UNITED STATES PATENT AND TRADEMARK OFFICE

Office Action Summary	Application No. 10/509,748	Applicant(s) IDE ET AL.	
	Examiner ALEXANDER B. COMLEY	Art Unit 3746

DETAILED ACTION

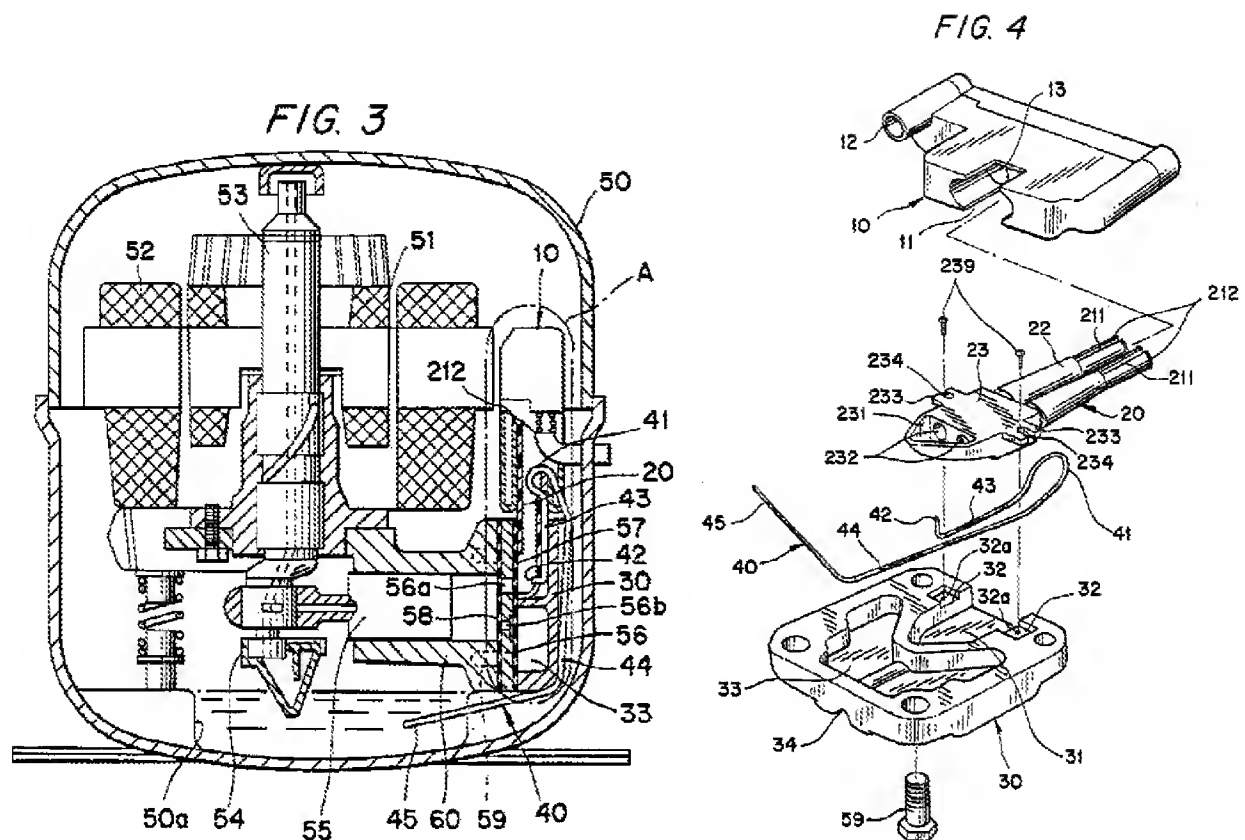
Regarding Independent Claim 1, and with reference to Figures 3 and 4 shown immediately above, Lee discloses:

A hermetic type compressor comprising: a hermetic container (50) which accommodates stored oil, an electric motor unit (51, 52) and a compressing unit, wherein the compressing unit comprises: a cylinder (60) for storing a reciprocally moving piston (55), a plate (56) disposed at an end of the cylinder (60), a suction muffler (10) having a connection pipe (22) communicated to a suction hole (56a) in the plate (56), and a cylinder head (30) disposed at the anti-cylinder side of the plate (56), and the cylinder head (30) is formed with a discharge chamber (33) and a resonance chamber (31) which communicates one side opened

connection pipe (22); a flange (233) of which shape is generally U-shaped having upper and lower surfaces and an outer periphery is disposed at an outer periphery of the connection pipe (22); the cylinder head (30) is provided with a generally U-shaped groove (234) to which the generally U-shaped flange (233) is fitted at a position corresponding to the flange (233); and by fitting the flange (233) into the groove (234), having an effective sealing width added to the upper and lower surfaces and the outer surface, thereby forming a seal portion so as to prevent a leakage of pressure pulsation in the resonance chamber (31) to the outside.

As shown in Figures 3 and 4 above, Lee discloses a hermetic compressor unit that utilizes a specially-designed suction muffler attachment structure designed to affix the muffler to the cylinder head using flange-and-groove connection means (See Fig. 4). In particular, Lee discloses "A pair of protruding ears 233 form nut fixing grooves 234 and are received by the concave grooves 32 formed at the sides of the suction chamber 31 in the cylinder head 30. The ears are fastened to holes 32a formed in the concave grooves 32 by fastening members 239." (Column 5, Lines 27-31) Therefore, it is clear that Lee's suction muffler is attached using U-shaped flanges placed within corresponding U-shaped grooves, and consequently, would provide improved sealing specifically at the resonance chamber interface.

5. Regarding dependent **Claims 6 & 7**, and with particular reference to Figure 4, Lee discloses a ring-like seat, or base 20, designed to be disposed along the inner wall

of the nearly-semi-circular resonance chamber 31 of the cylinder head 30. In particular, Lee discloses "The cylinder head 30 has an inner side surface formed with (i) a discharge chamber 33 for conducting the refrigerant compressed to high pressure and high temperature by the piston 55 in the cylinder block 60, and (ii) a receptacle groove 31 on which a base unit 23 of a base muffler 20 is seated" (Column 4, Lines 32-37)

12. In regards to applicant's assertions that the Lee ('106) reference fails to teach a U-shaped groove to which a generally U-shaped flange is fitted specifically at the interface between the resonance chamber and the suction muffler, the examiner has applied new reference Lee ('824) which specifically teaches the use of a generally U-shaped flange fitted into a generally U-shaped receiving groove. Please see Figure 4 shown previously above, as well as the analysis for Independent Claim 1. Lee's flange-and-groove structure is one that is located specifically at the interface between the resonance chamber and the suction muffler base, and consequently, leakage at the interface between the resonance chamber 31 and suction muffler base 20 is lessened.

13. Regarding applicant's assertion that the specification describes the drawback of leakage specifically at the resonance space/connection pipe interface, it is clear that the newly applied structure of Lee ('824) would help prevent leakage specifically at this interface (See Figure 4 above, as well as Figure 7 of Lee '824)

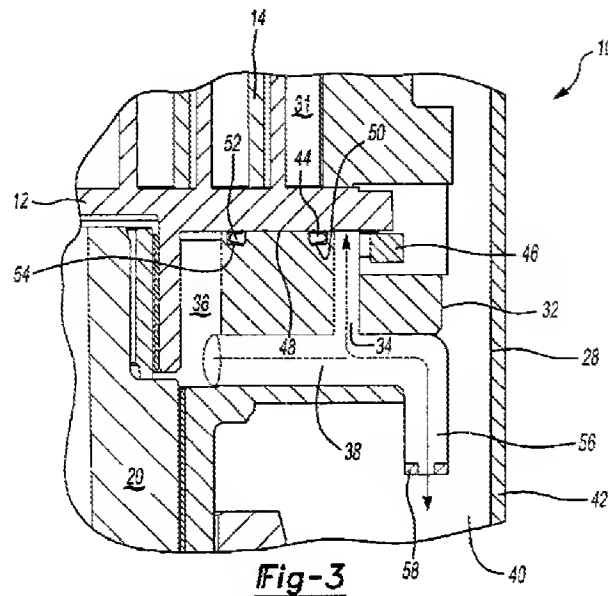
Lee does not disclose an oil hole disposed at the bottom of the suction muffler specifically for allowing oil to lubricate the seal portion (although Lee does disclose an oil hole located at the bottom of the suction muffler). However, Fenocchi specifically discloses, in Figure 3 seen above, a compressor having an oil spout 34 that redirects a portion of oil entering an oil return passage 38 to supply lubrication between an outer seal 44 and a coupling 46. Fenocchi's setup provides enhanced seal reliability, as made clear by Fenocchi stating "The oil spout provides a continual flow of lubrication to the outer seal and the coupling, preventing excessive wear of the outer seal and improving seal reliability" (Column 1, Lines 54-56). Therefore, to one of ordinary skill desiring enhanced seal life through lubrication, it would have been obvious to utilize the techniques disclosed in Lee in combination with those seen in Fenocchi in order to obtain such a result. Consequently, it would have been obvious to one of ordinary skill in the art at the time of the invention to modify the suction muffler and suction base of Lee with an oil hole similar to that of Fenocchi in order to obtain predictable results;

those results being a more tightly-sealed suction muffler that greatly minimizes audible annoyances while lengthening the overall seal life.

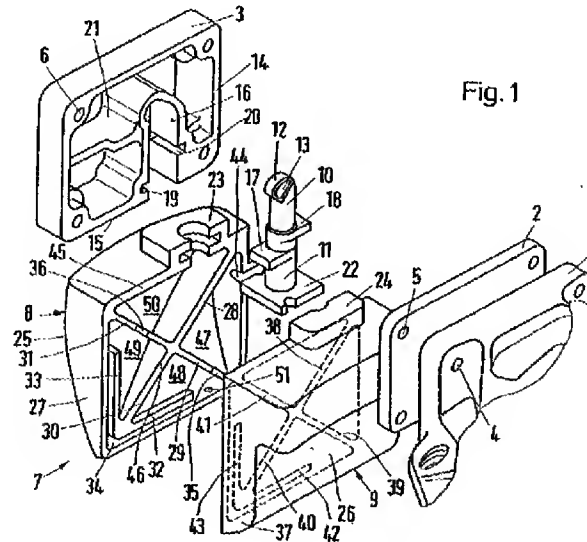
Lee does not specifically disclose that the resonance frequency of the suction muffler opening is coincident with the resonance frequency of a resonance muffler. However, Outzen discloses the use of appropriately selected resonance frequencies when and if less noise is desired. In particular, Outzen discloses a suction sound damper designed to eliminate resonance oscillations altogether by stating "It is particularly favourable for the shells to be substantially rectangular...Such a suction sound damper can be accommodated in the capsule to save space and has an

extraordinary strength which ensures that resonance oscillations of the housing do not occur at all or lie above the hearing threshold" (Column 2, Lines 67-68; Column 3, Lines 1-6) Consequently, it would have been obvious at the time the invention was made to disclose in either Lee or Outzen that the resonance frequencies are the same for the suction muffler opening and the resonance muffler. Therefore, to one of ordinary skill desiring a hermetic compressor that minimizes operating noise, it would have been obvious to utilize the techniques disclosed in Lee in combination with those seen in Outzen in order to obtain such a result. Consequently, it would have been obvious to one of ordinary skill in the art at the time of the invention to modify the sealing structure of Lee with the appropriately tuned frequencies of Outzen in order to obtain predictable results; those results being a much quieter compressor that eliminates much of the audible annoyances associated with comparable compressors.

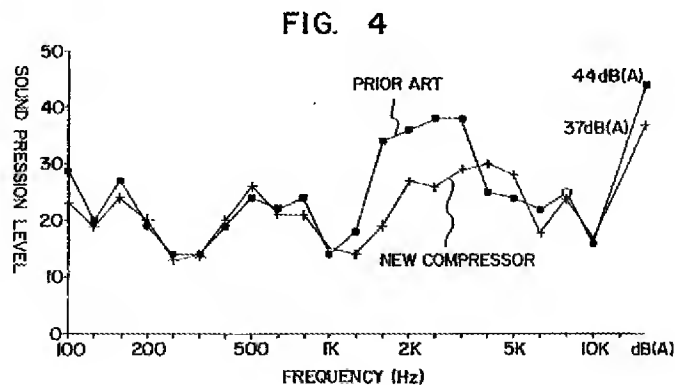
Lee does not disclose that the resonance frequency of a plane portion of the hermetic container and the resonance frequency of the opening of the suction muffler are independent of each other. However, Alfano et al. specifically discloses the particular method of designing the container to have a resonance frequency different than that of motor compressor itself. In particular, Alfano states, "In the hermetic motor compressors for home refrigerators, beside the efficiency, a very important issue is the noise produced by the motor compressor and transmitted outside by the shell. It is known that for reducing the noise it is necessary to shape the shell in such a way that its resonance frequency is different from the frequency of the motor compressor." (Column 1, Lines 23-29) Therefore, since the suction muffler together with the motor may form the "motor compressor", Alfano et al. makes it obvious to vary the frequencies of the hermetic container and the suction muffler. Therefore, to one of ordinary skill desiring a quieter compressor unit, it would have been obvious to utilize the techniques disclosed in Lee in combination with those seen in Alfano in order to obtain such a result. Consequently, it would have been obvious to one of ordinary skill in the art at the time of the invention to modify the compressor structure of Lee with the differing resonant frequencies of Alfano et al. in order to obtain predictable results; those results being a much quieter compressor that eliminates much of the audible annoyances associated with comparable compressors.
